3.0 LIMITING CONDITION FOR OPERATION (LCO) APPLICABILITY

The information in this section of the reference ABWR DCD, including all subsections, is incorporated by reference with the following departure.

STP DEP 16.3-1

Figure B 3.3.1.4-1 ESF Actuation Channel Structure for Containment Isolation, ESF Support

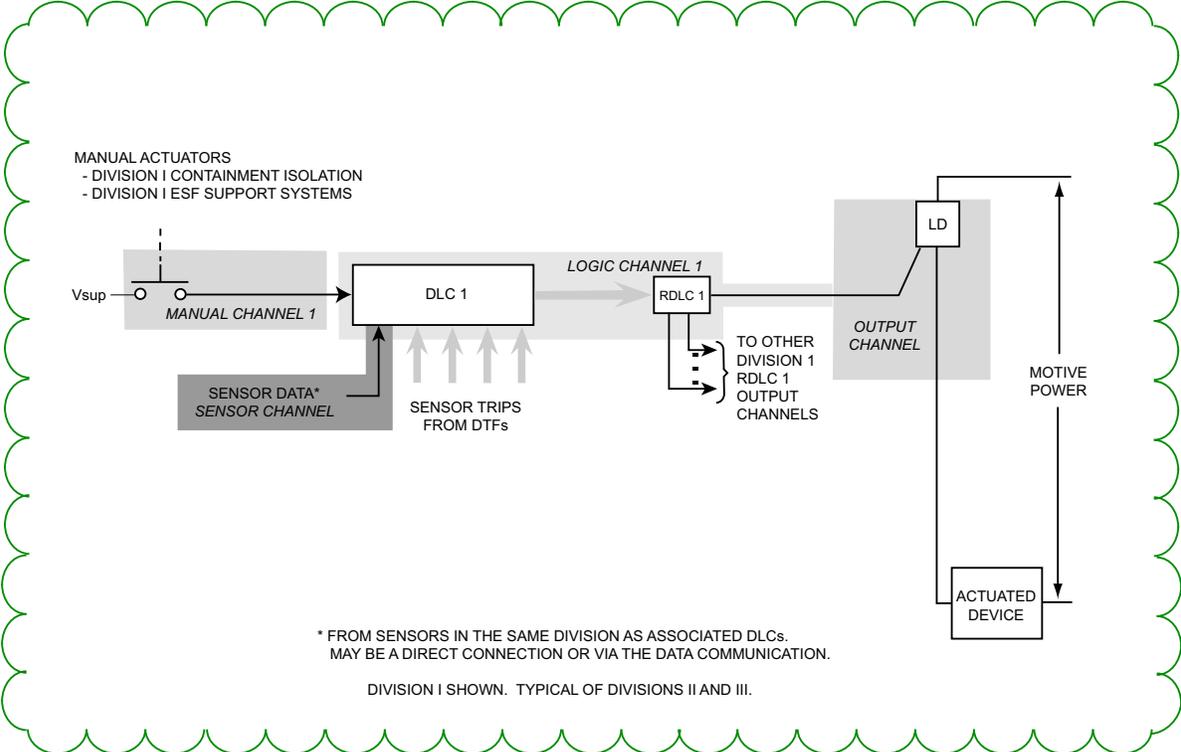
STD DEP T1 3.4-1 This figure replaces Figure B 3.3.1.4-1.

Figure B 3.3.1.4-2 ESF Actuation Channel Structure for LPFL B, C, HPCF B, RCIC

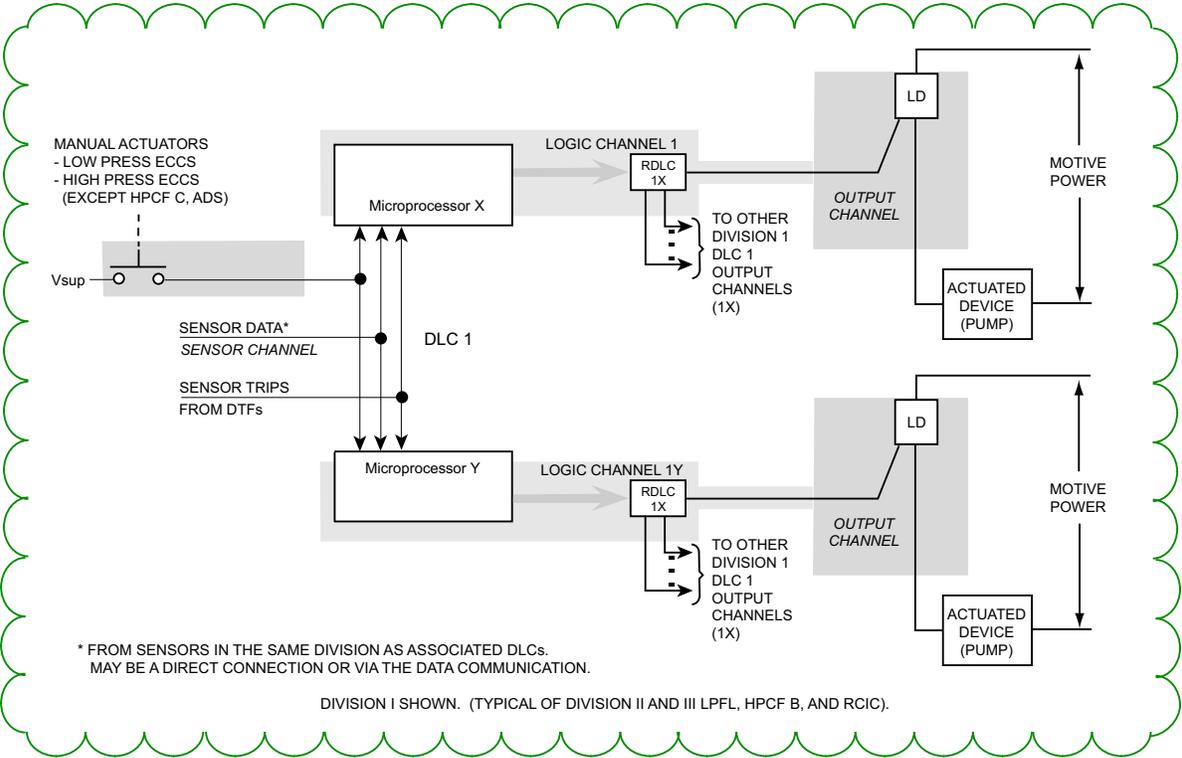
STD DEP T1 3.4-1 This figure replaces Figure B 3.3.1.4-2.

Figure B 3.3.1.4-3 ESF Actuation Channel Structure for HPCF C

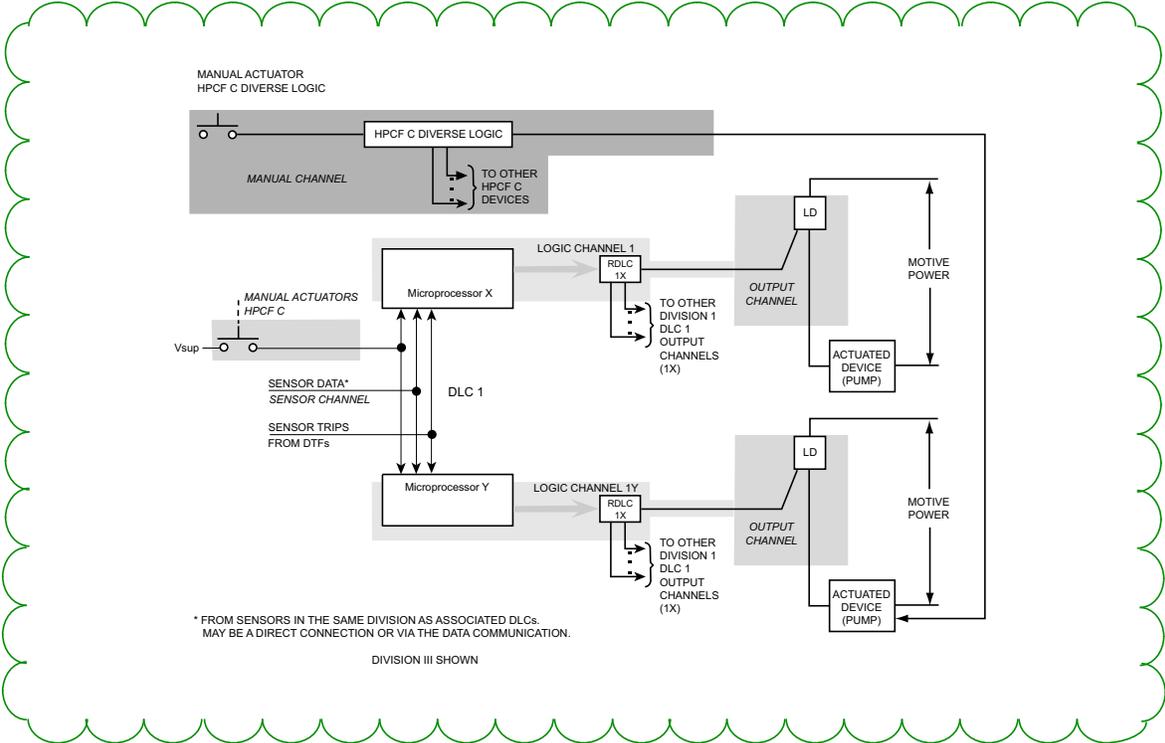
STD DEP T1 3.4-1 This figure replaces Figure B 3.3.1.4-3.

Figure B 3.3.1.4-4 ESF Actuation Channel Structure for ADS

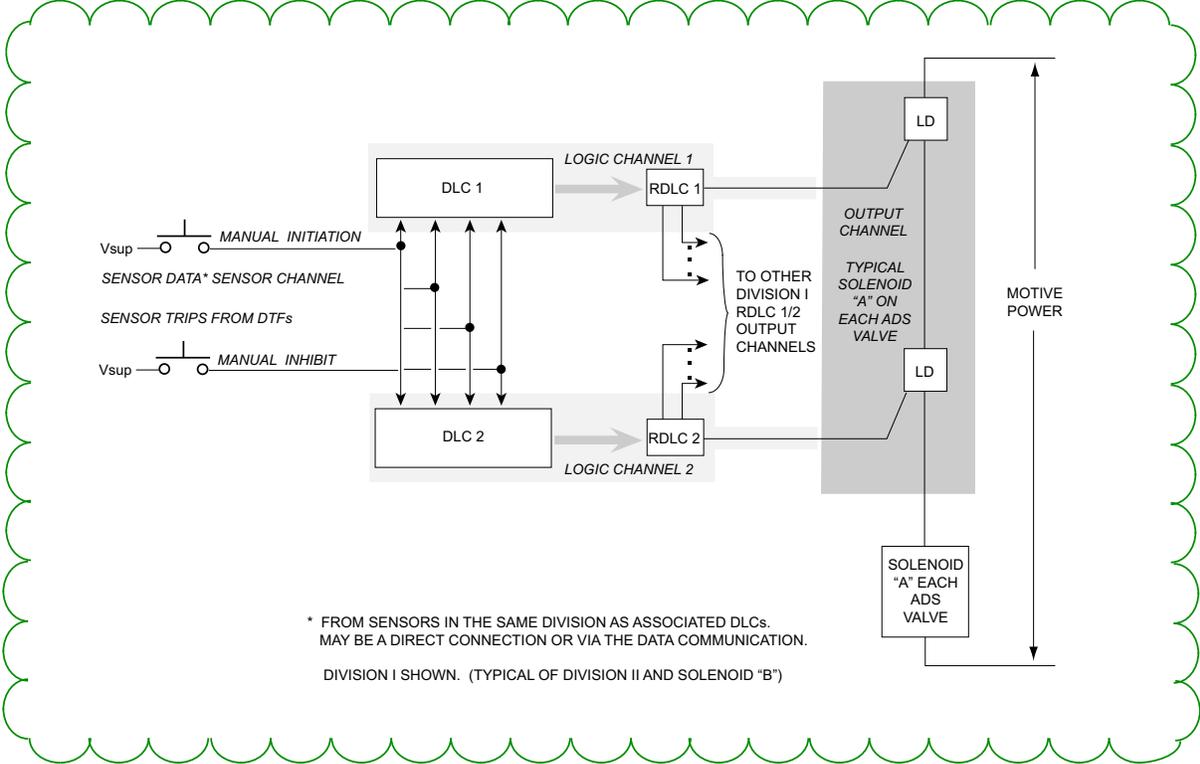
STD DEP T1 3.4-1 This figure replaces Figure B 3.3.1.4-4.

Figure B 3.3.1.4-5 ESF Actuation Channel Structure for RCW/RSWW Isolation

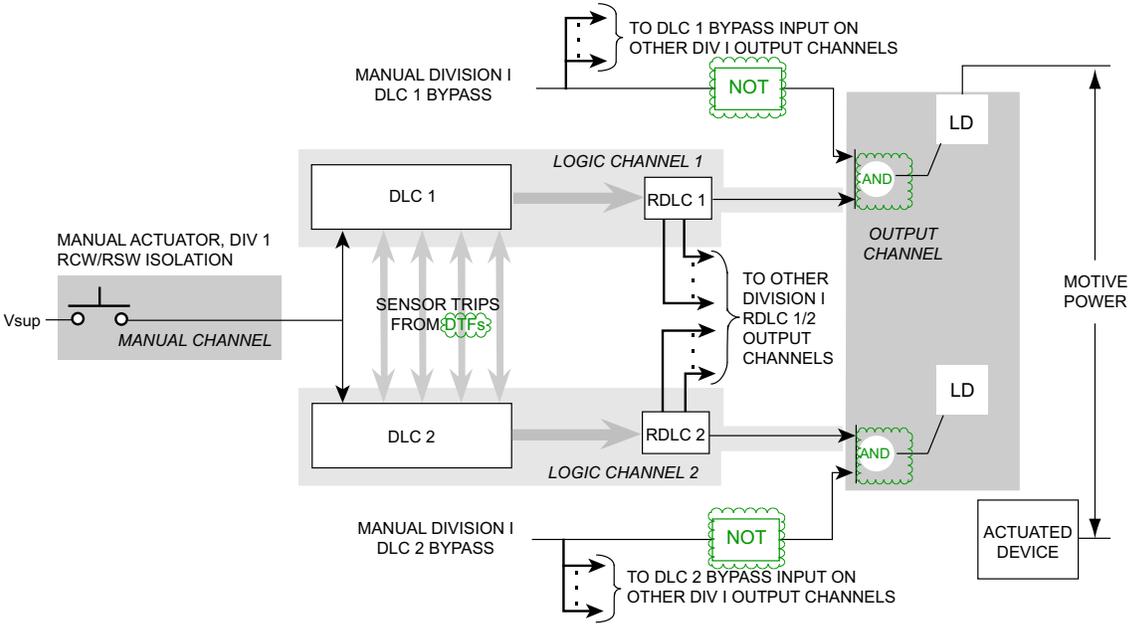
STD DEP T1 3.4-1 This figure replaces Figure B 3.3.1.4-5.
